Re: Summary of April 27 and 28, 1993 Meetings Concerning the Tutu Service Station Investigation in St. Thomas, U.S. Virgin Islands.

On behalf of the Tutu Environmental Investigation Committee (TEIC), Geraghty & Miller, Inc. has prepared this letter to confirm the agreements reached at the April 27 and 28, 1993 meetings, at the Nisky Center in St. Thomas, U.S. Virgin Islands between representatives of the U.S. Environmental Protection Agency (USEPA), the U.S. Virgin Islands Department of Planning and Natural Resources (DPNR), and the TEIC. These meetings were held to discuss the USEPA's comments on the first draft of the Technical Memorandum II of the Tutu Service Station Investigation in St. Thomas which was submitted to the USEPA by TEIC on March 1, 1993. The USEPA's comments were provided in an April 20, 1993 letter from Ms. Carole Peterson, USEPA Chief, New York/Caribbean Superfund Branch II to Ms. Ana Gloria Ramos, Designated Coordinator for the TEIC.

It was agreed that Technical Memorandum II will be revised to incorporate the USEPA's comments and the revised memorandum will be submitted to the USEPA by May 24, 1993.

**LOCATION OF PROPOSED MONITORING
WELL MW-15**

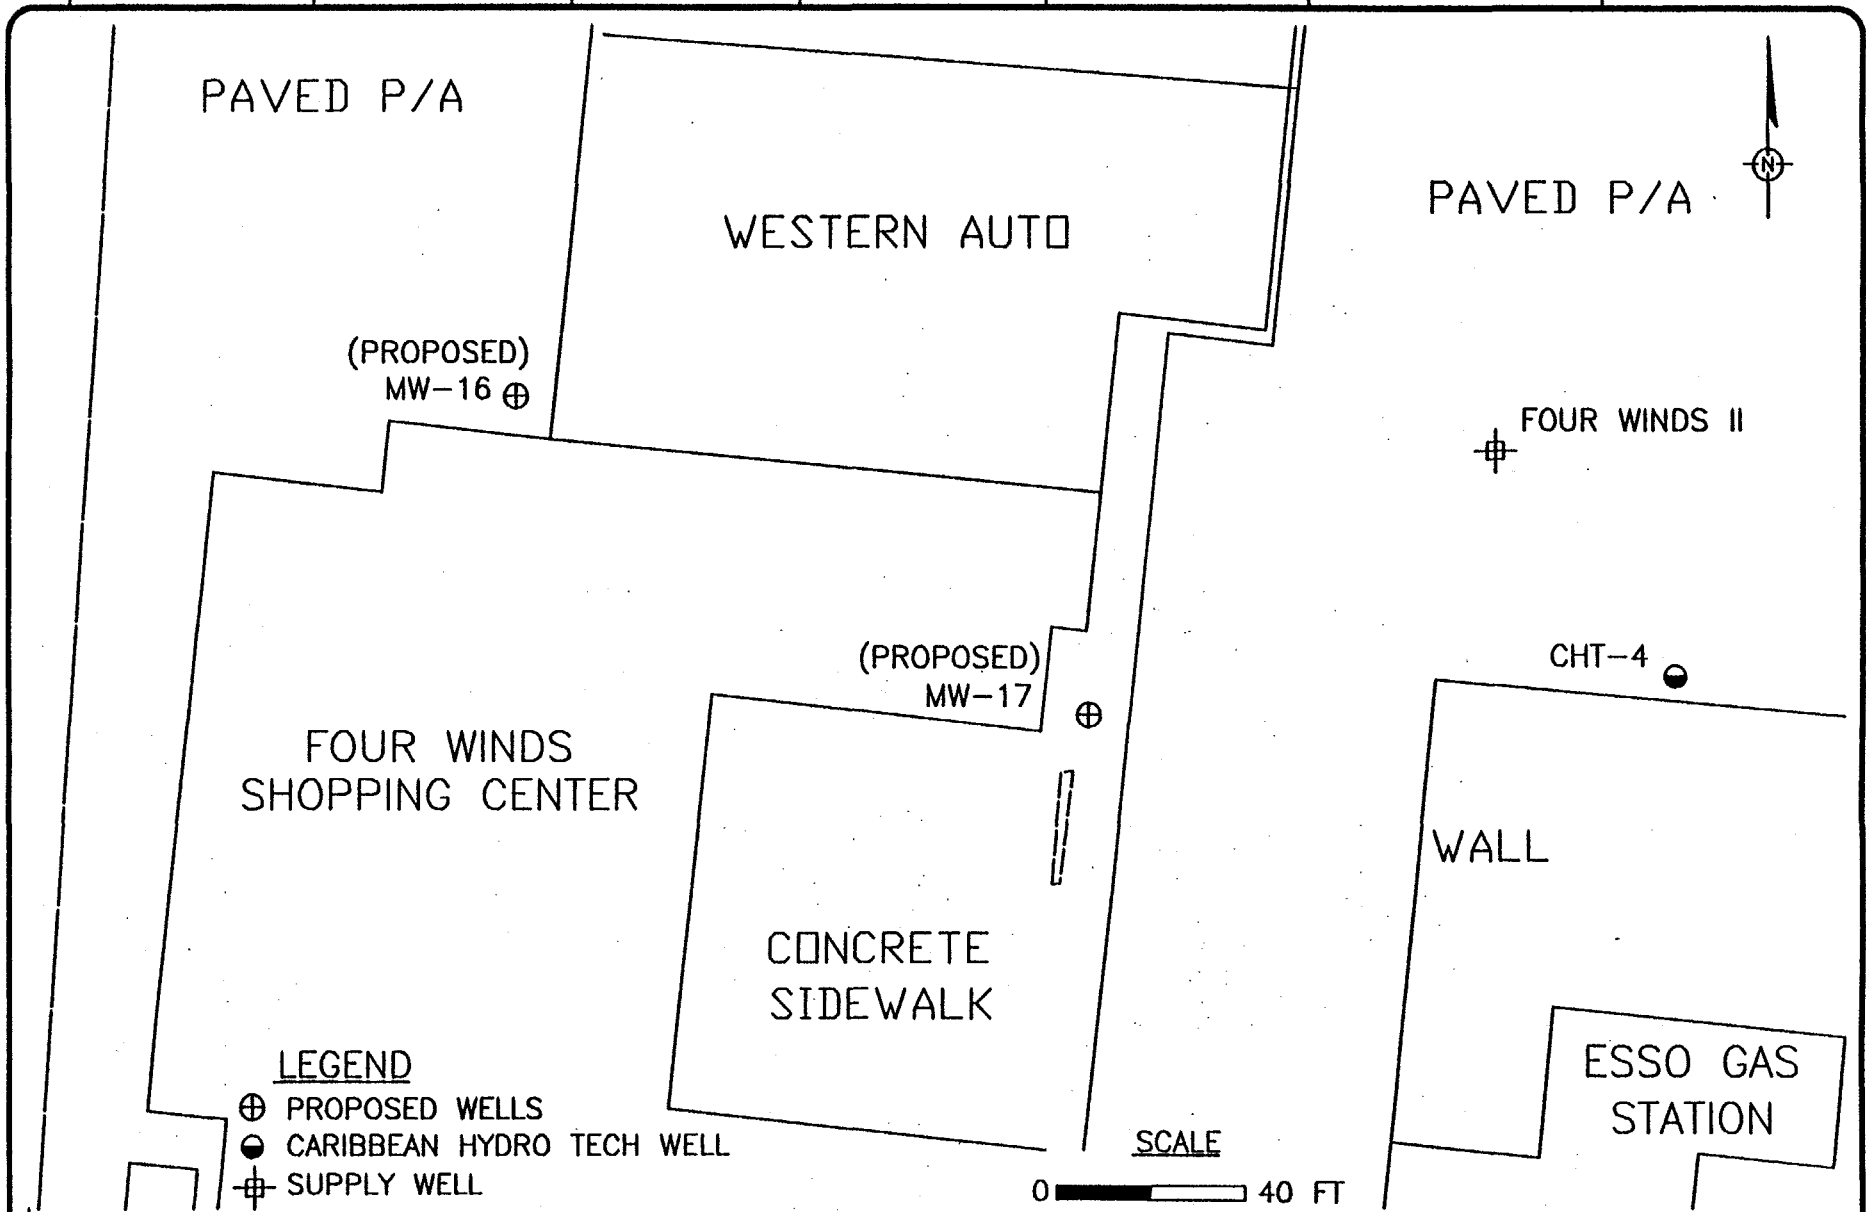
Based on the maps, it appears that the upgradient extent of petroleum contamination can be delineated without the three additional wells proposed in the Technical Memo. However, one well might be warranted to the west of Western Auto, to establish whether that facility contributes to groundwater contamination. The locations of the proposed wells should be plotted on a map. Several questions remain as to the sources of chlorinated volatile organic compounds (VOCs) in groundwater. There are apparently at least two sources of chlorinated VOCs at the site - one in the vicinity of the Curriculum Building and, possibly, Tillet Gardens; the second in the vicinity of O'Henri cleaners. A shallow well should be installed south of MW-12D to identify and delineate the southern extent of the VOCs plume to the northern extent of the VOCs plume and to ascertain if the northern and southern plumes are connected.

Page 6-5, Paragraph 3 - Based on the groundwater results presented in this report, it appears that the upgradient extent of petroleum constituents can be defined with the existing data. Additional wells might be warranted to conclusively establish liability with respect to chlorinated compounds.

The locations for the proposed additional monitoring wells were field checked by the USEPA and TEIC representatives after the meeting on April 27, 1993. The proposed locations for the four additional shallow monitoring wells MW-15 through MW-18 are shown on Figures 1-1, 1-2, and 1-3 (enclosed).

As discussed at the meetings, the potential impact of the underground storage tanks (USTs) west of Western Auto in the Four Winds Plaza warrants the installation of the two additional monitoring wells, shown as Monitoring Wells MW-16 and MW-17 on Figure 1.

The proposed Monitoring Well MW-15 at Ramsay is necessary to evaluate the potential impacts to ground-water quality, in light of the elevated BNAs detected in Boring B-2.

LOCATION OF PROPOSED MONITORING WELL MW-18

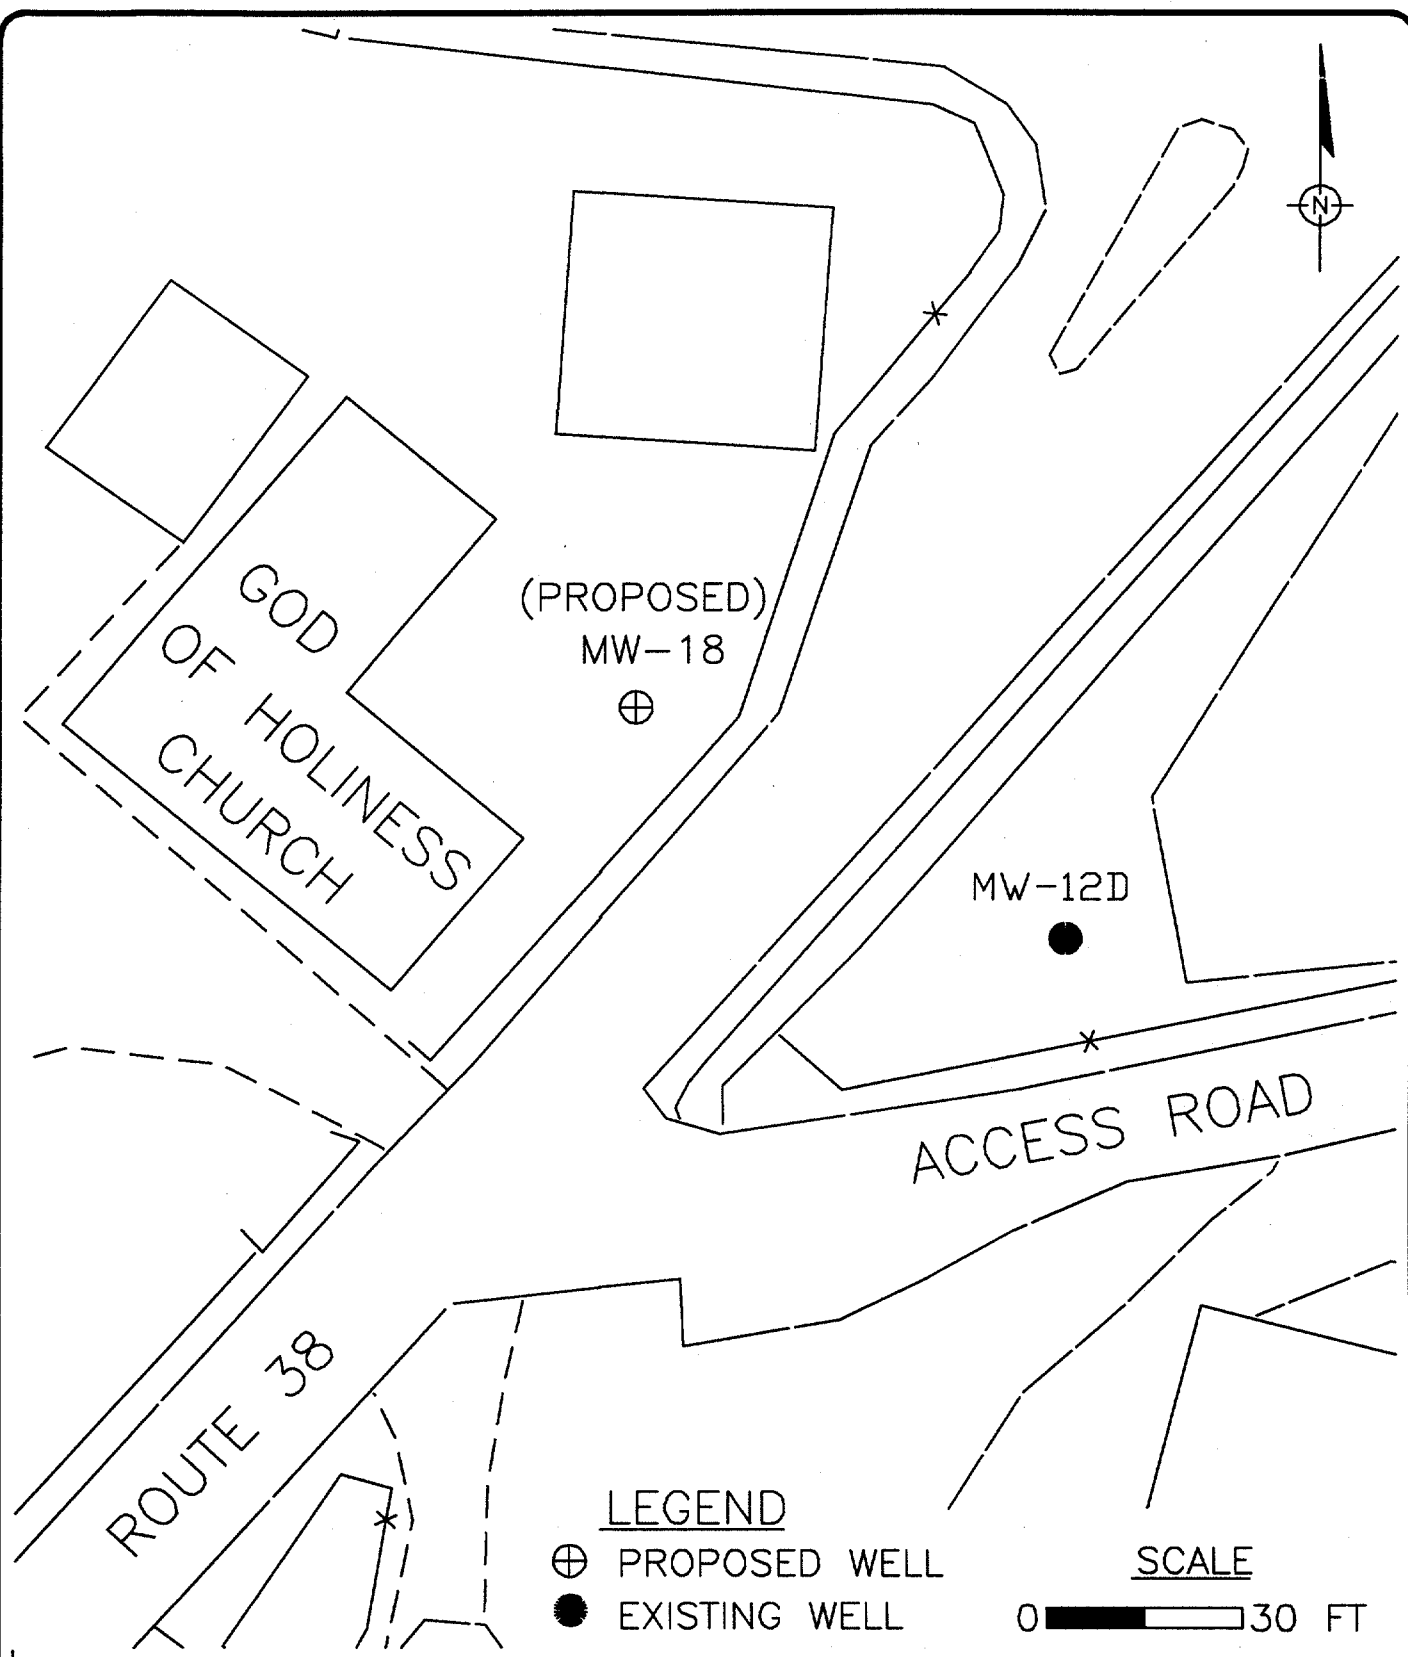
In Section 7 of the Technical Memo II, recommendation for future activities include resampling of all monitoring wells, installation of three monitoring wells near Western Auto and Ramsay Auto property. As stated in the general comments above, one additional well is needed west of Western Auto instead of two wells proposed in the Technical Memo II. Instead, MW-9 and MW-2 could serve the same purpose of the two additional wells proposed. For the VOCs plumes, a shallow well is required to identify and ascertain the extent of the southern VOCs plume to the northern VOCs plume.

As agreed at the meeting, four additional shallow monitoring wells (Monitoring Wells MW-15 through MW-18) will be installed. The rationale and purpose of proposed Monitoring Wells MW-15, MW-16, and MW-17 have been presented in Item 27 above. Monitoring Well MW-18 will be installed between existing Monitoring Wells MW-11D and MW-12D to (1) evaluate concentrations of benzene, toluene, ethylbenzene, and xylene (BTEX) in shallow ground water downgradient of existing Monitoring Wells MW-9 and MW-9S; and (2) evaluate chlorinated hydrocarbon concentrations in shallow ground water in the area.
